Access Compliance Report

Public Rights-of-Way

(Pedestrian Signals)

Intersection ID: N/A	Main Street:	Cross Street: N/A	Location: N/A
ADA ID: E327525A9F26	Signal Type: One Push Button-Non APS	Overall Compliance: No	Severity Score: BTN 1: N/A BTN 2: N/A No BTN: N/A
Codes/Mitigation Info/Possible Solution		Field Measurements/Component Compliance

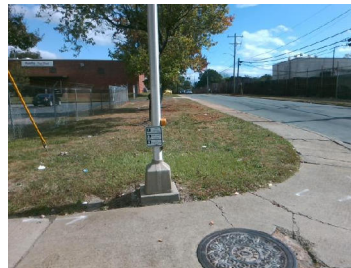
Possible Solutions: Replace Signal Push Button With APS Button on New Post. Remove & Relocate Sign.

PROW/ADA: TMUTCD 4e.08, R404.2, R404.3, R406.2
